## Evita 4

### Technical Service Bulletin # 29

**Re:** Product improvement for all units before S/N ARNB-0070  
(Service Pack 1)

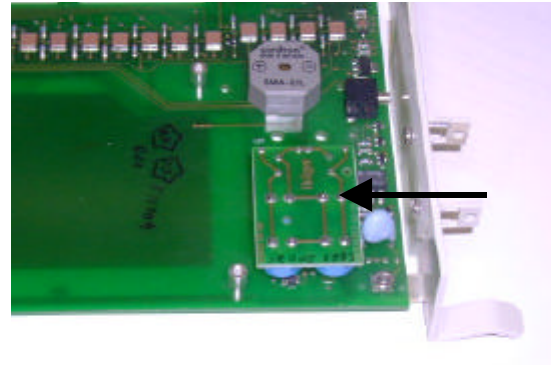
- The kit is delivered with 2 modified Expiration Valve caps to prevent tendency of resonance vibration. Note: Not all valves are affected.
- A second loudspeaker is installed in most units starting with a S/N ARMX-YYYY (1998 production). Some users/operators complained that the audible alarms are too loud. If applicable, the second loudspeaker is to be disconnected. The cable harness with the connector must be fasten with a cable tie in such way that an electrical contact to housing or other parts is not possible.

**Solution:** Installation of Kit Service Pack 1.
